BUI83, BUI83A, & BUI83M

SUPPLEMENTARY SERVICE INSTRUCTIONS

To be used in conjunction with the BUI83 Service Instructions Manual.

Fig. 5. This diagram applies to the later BU183A models, as well as to the BU183M.

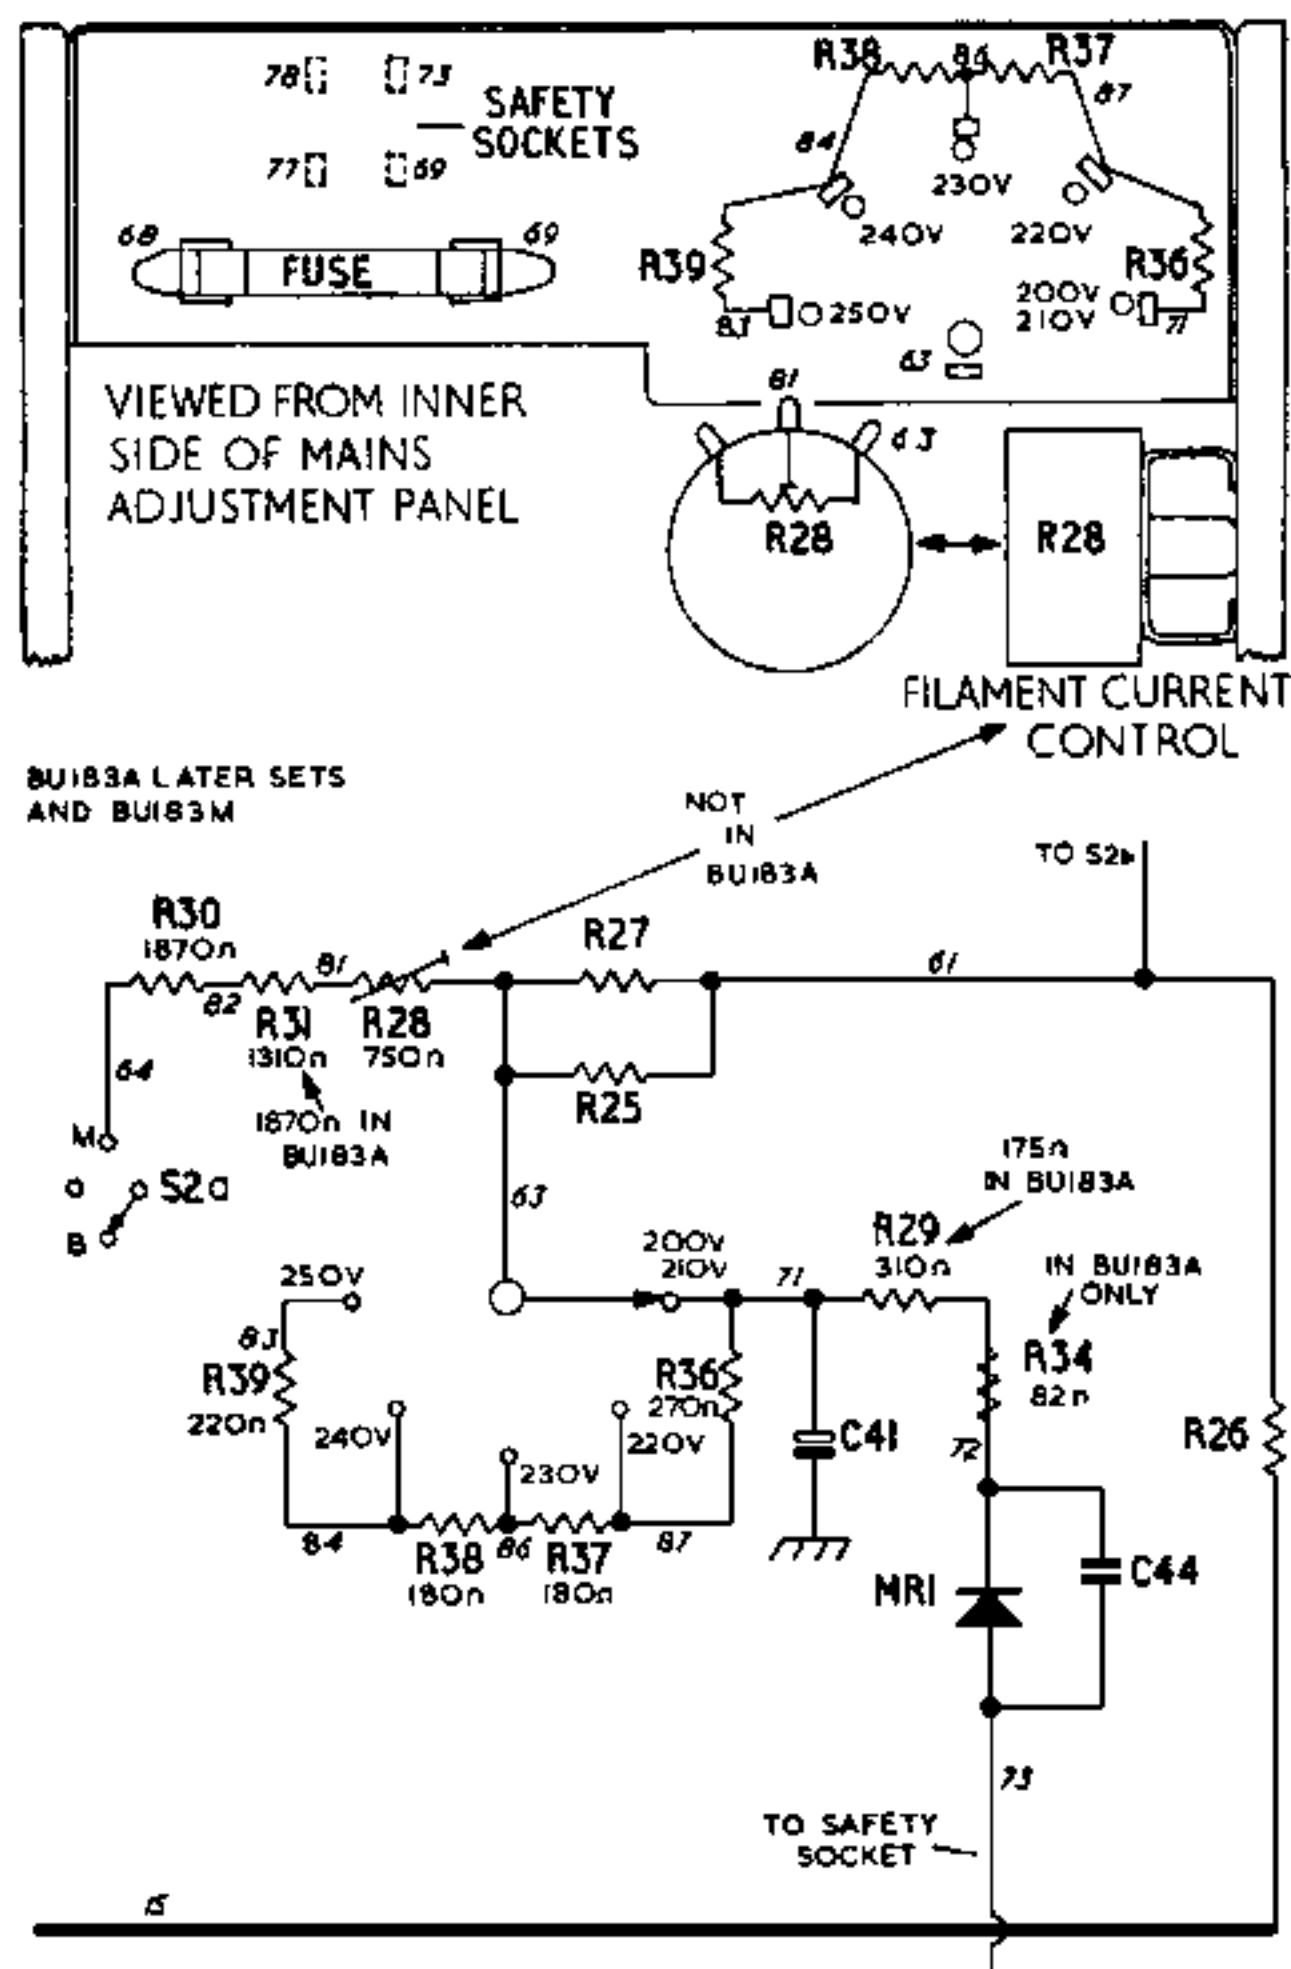
Mains tapping points. To compensate more closely for changes in valve filament current when the receiver is connected to alternative mains supply voltages, the mains tapping points have been increased from two to five. Referring to the circuit diagram on page 9, the resistor R28 and the two position mains adjustor have been replaced by four new resistors and a five position mains adjustor. The new arrangement of the mains tapping panel is as shown at the top of Fig. 5 in this Supplementary Instruction sheet.

Filament circuit current control. To provide improved control and balance of the valve filament current the following changes have been made:

A 750 Ω variable resistor (Filament Current control, R28) is connected in series with R31 (see Fig. 5), and R31 itself is reduced from 1870 Ω (BU183A) to 1310 Ω . The new control is mounted on a bracket fixed to the frame aerial board.

The mains resistor R29 is increased from 175 Ω to 310 Ω , and R34 (BU183A) is deleted.

V1 filament resistor (R3) is changed from 270 Ω (BU183A) to 150 Ω .

V2 filament resistor (R7) is changed from 180 Ω to 150 Ω .

V4 filament resistor (R21) is changed from 390 Ω to 270 Ω .

The Filament Current control (R28) is adjusted in the factory to give the correct filament current and its setting should not be altered unless there is good reason. In a series filament circuit of this type the current is largely independent of valve tolerances but it is affected by the tolerances of the mains rectifier (MR1). Therefore, if MR1 is replaced, R28 must be reset to give a filament line current of 58mA; use a good quality meter which is known to be accurate to within 1mA and connect it in series with the heater line between V1 and V3 at V1 pin 1. If the possible meter error is 2mA or more, then R28 is better left alone.
